EA Engineering, Science,  
and Technology, Inc.

RE: Expansion of LOOW Phase II RI (Response to Phase II RI Letter 01)

SUBJECT: Phase II RI Letter 01

## 20 JULY 2000 ADDITIONS TO THE SAMPLING AND ANALYSIS PLAN (SAP) FOR AREAS 2 AND 20

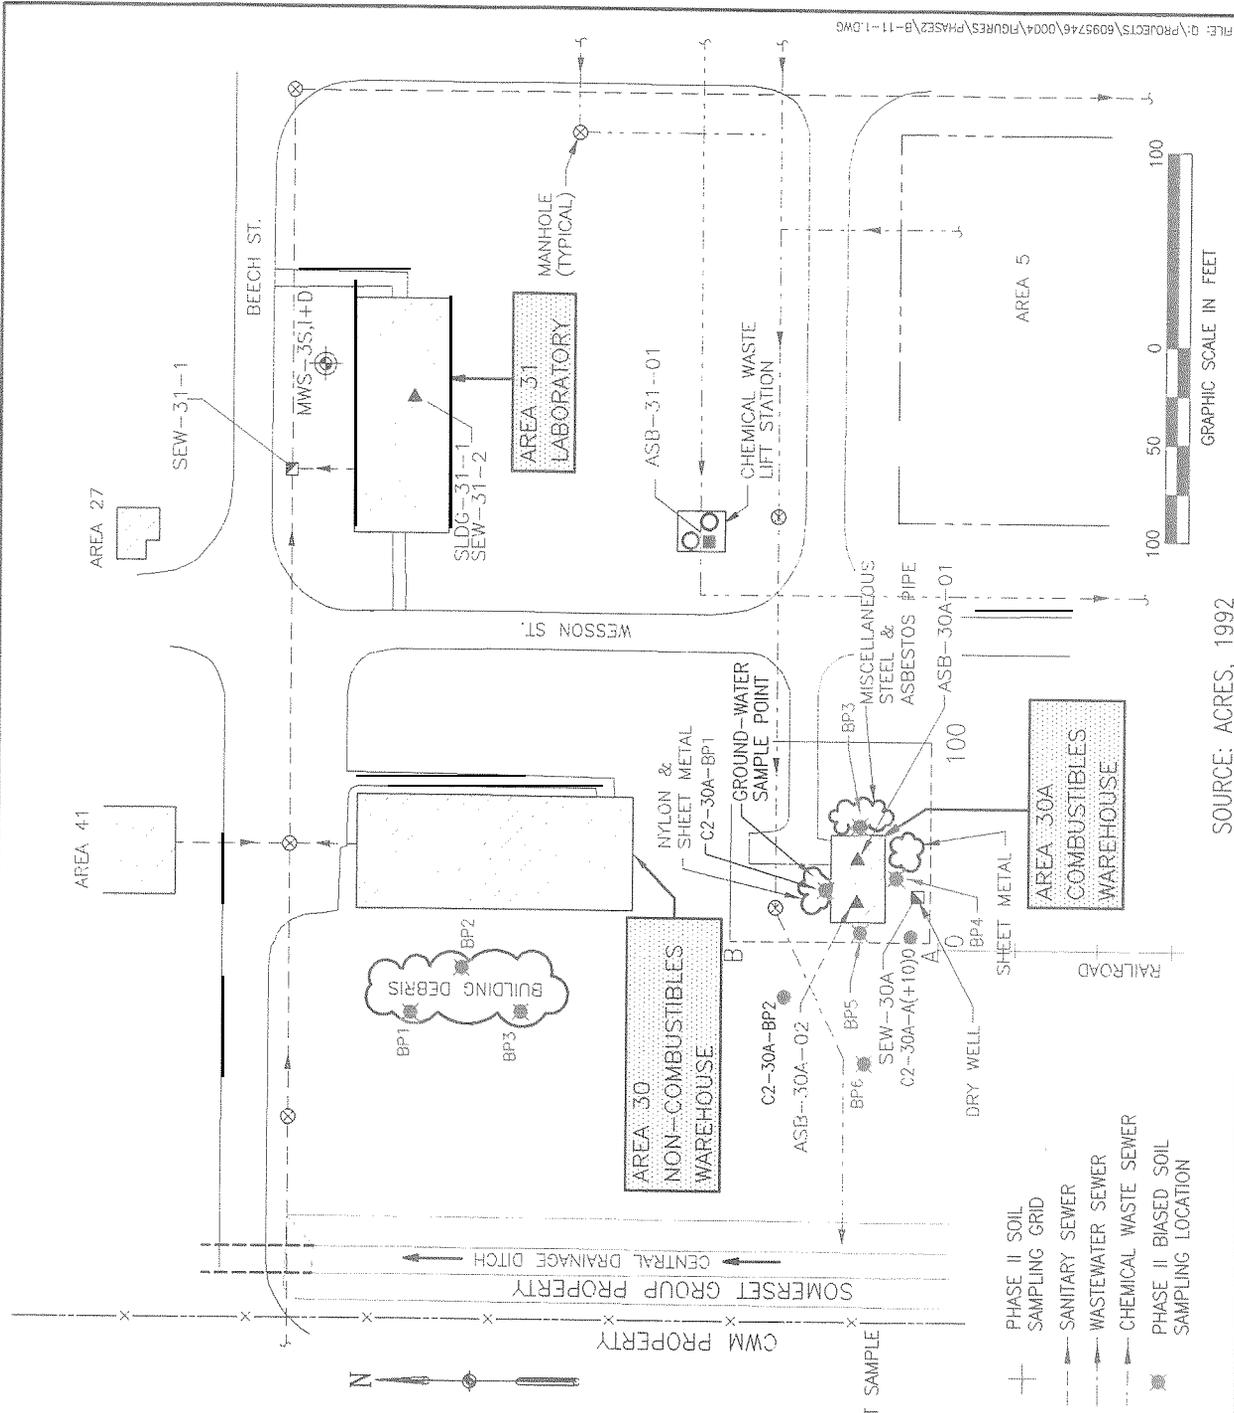
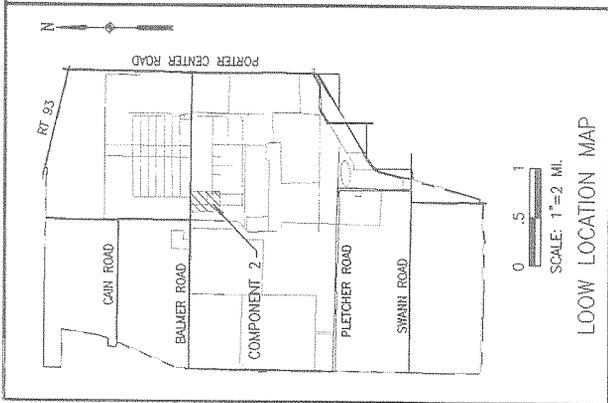
Because Area 30 was not included in the original Phase II investigation, a SAP does not currently exist. Area 30 was not included in the original scope of the Phase II RI due to previous use of Building 30-1 for storage by the current land owner. However, a debris pile west of the building appears to be a relict from decommissioning of AFP-68. An investigation of the debris pile was approved by the USACE in the letter dated 20 July 2000. The investigation shall include the following:

A reconnaissance of the debris pile will be performed to evaluate whether there appears to be debris not associated with the decommissioning of the AFP-68. This evaluation will be qualitative and will be made by assessing the relative age of the material based on weathering, potential dated material, potentially recovered model numbers of debris pile constituents. A photograph log will also be completed for the debris pile. If the age evaluation indicates that the debris is not recently deposited, but may have been deposited during decommissioning of the plant, three sampling locations will be established (see revised Figure B- 1 1- 1).

A direct push rig will be used to collect a surface soil sample (0 to 0.5 ft bgs), a semi-subsurface soil sample (4 to 5 ft bgs), and a subsurface soil sample (near the upper tills, Glaciolacustrine Clay contact). The sample intervals may be changed at the discretion of the field geologist based on possible observations of elevated organic vapor concentrations or soil staining.

The samples will be field screened for total PAHs, total PCBs, TNT, and VOCs in accordance with SOPs established for the Phase II RI. The location exhibiting the highest concentration of constituents, based on the results of the field screening, will be re-sampled for laboratory confirmatory information. During the re-sampling, a surface soil sample (for to aid in evaluation of risk assessment) and the subsurface soil sample, from the interval exhibiting the highest concentrations of constituents, will be submitted to the laboratory for analysis of full suite parameters as listed in Table B-1 1-3.
